State of New Mexico  
Energy, Minerals and Natural Resources Department

API WELL #	Well Name	Well #	Operator Name	Type	Stat	County	Surf. Owner	UL	Sec	Twp	N/S	Rng	W/E
30-039-05806-00-00	JICARILLA C	011	FOUR STAR OIL & GAS CO	G	A	Rio Arriba	J	L	27	25	N	5	W

UNITED STATES  
DEPARTMENT OF THE INTERIOR  
BUREAU OF LAND MANAGEMENTFORM APPROVED  
OMB NO. 1004-0135  
Expires: July 31, 2010**SUNDRY NOTICES AND REPORTS ON WELLS**  
*Do not use this form for proposals to drill or to re-enter an abandoned well. Use form 3160-3 (APD) for such proposals.***SUBMIT IN TRIPLICATE - Other instructions on reverse side.**

Re: Permanent Abandonment  
Well: 11 Jicarilla C

Jicarilla C-11  
Rio Arriba County, New Mexico  
Current Well Schematic as of 09-19-2006

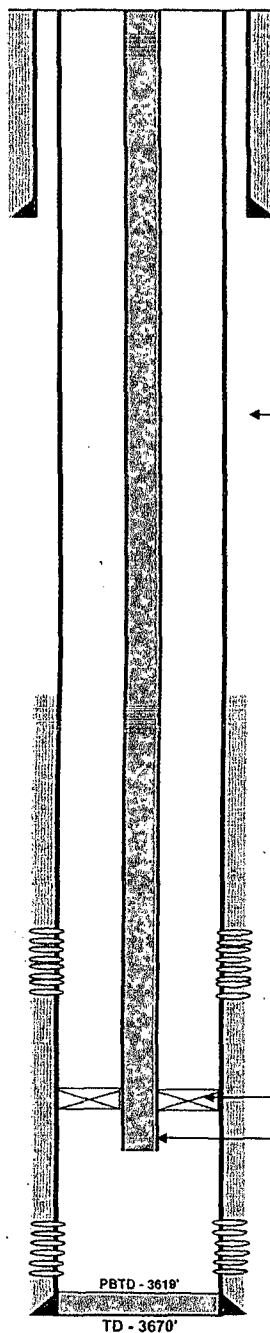
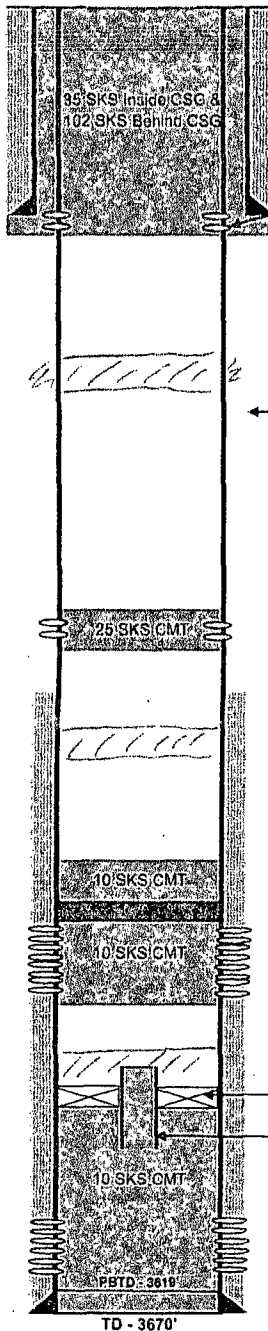
Forwarded plus from 2:50' - 2450'

Plg from 2395' - 2150' inside & outside the 5-1/2" casing

Plg from 800' - 780' inside & outside the 5-1/2" to cover the Macmillan top.

1. Plugging operations authorized are subject to the attached "General Requirements for Permanent Abandonment of Wells on Federal and Indian Lease."
2. Farmington Office is to be notified at least 24 hours before the plugging operations commence (505) 564-7750.
3. The following modifications to your plugging program are to be made:
  - a) Place at least a 50' cement plug on top of the Chacra packer.
  - b) Place the Fruitland plug from 2550' – 2450'.
  - c) Place the Kirtland/Ojo Alamo plug from 2395' - 2158' inside and outside the 5 ½" casing.
  - d) Place the Nacimiento plug from 880' - 780' inside and outside the 5 ½" casing.
